SERVICE BULLETIN

SB No. 96 Issue No. 1

TITLE
INSPECTION AND REPLACEMENT OF TRIM WHEEL THRUST WASHERS
CLASSIFICATION

FIG 1
ELECTRIC TRIM DRIVE
THRUST WASHER LOCATION

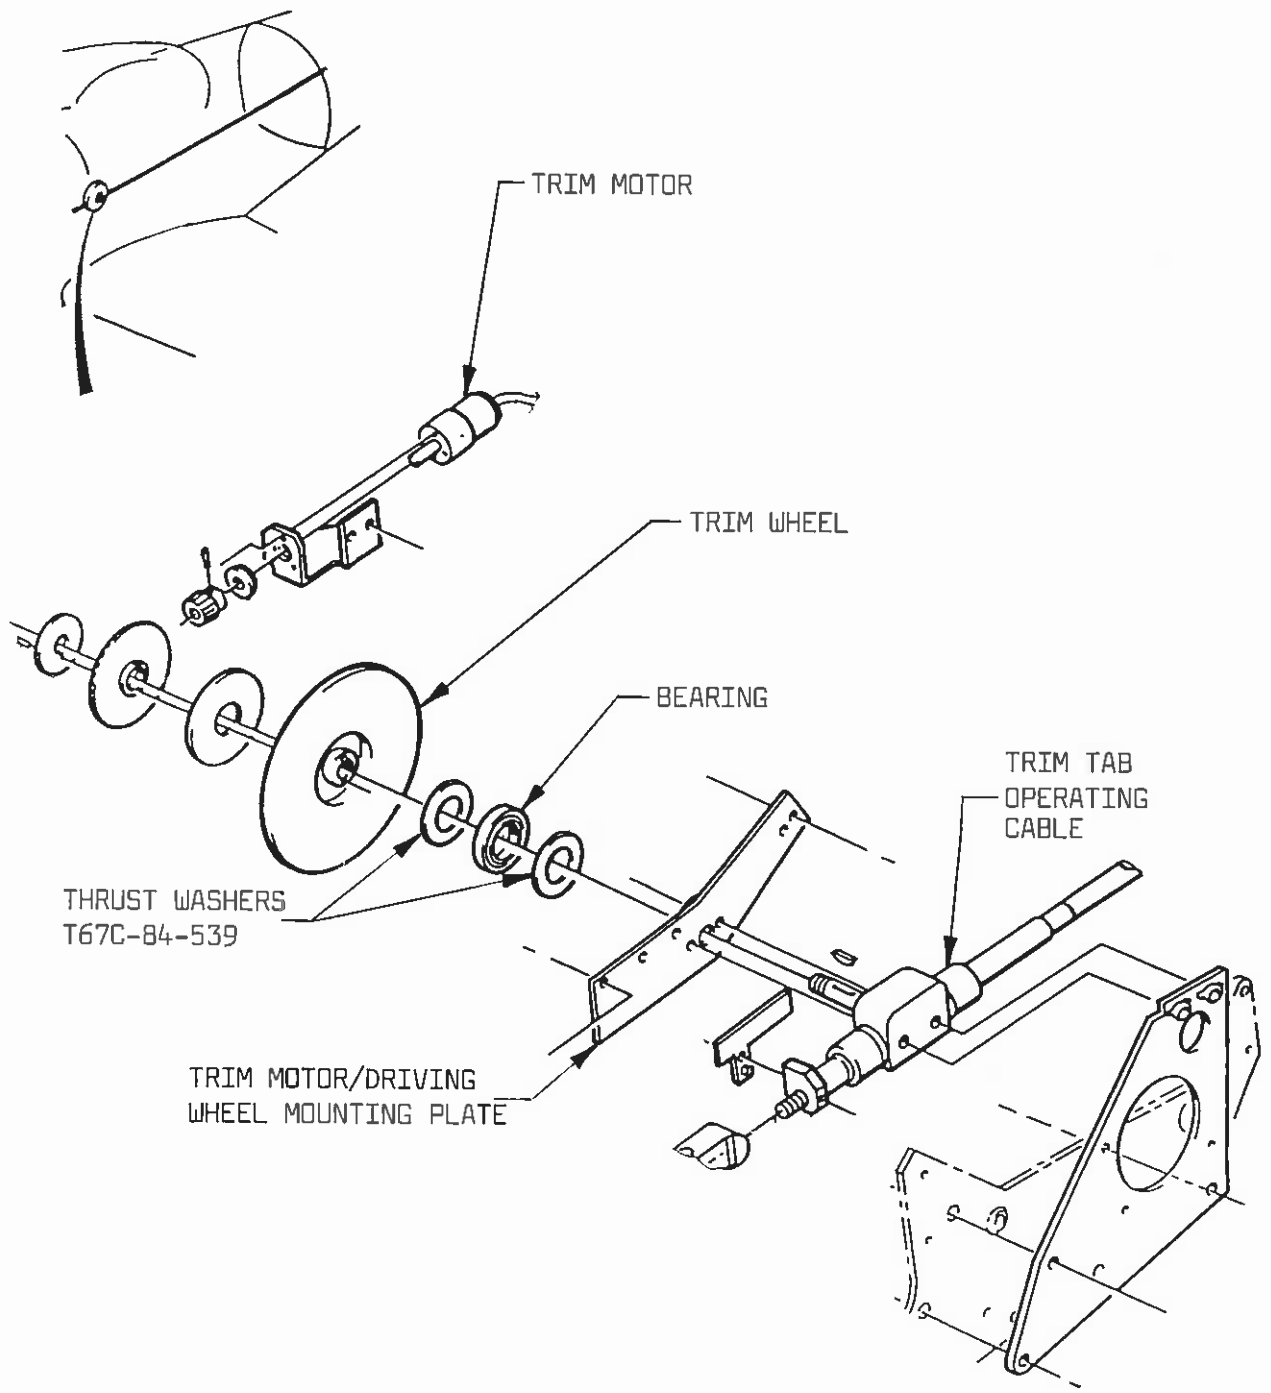
1. Gain access to trim motor and its thrust washers. Ref. Fig. 1.
2. Remove thrust washers.
3. Inspect thrust washers for the following:
 - i) Indentations, ref Fig. 2. If any found, replace with new component.
 - ii) Excessive grooving, ref Fig. 3. If groove measures greater than 1mm wide, replace with new components. Partial grooving is acceptable provided the grooved area is not wider than 1mm, ref Fig 4.
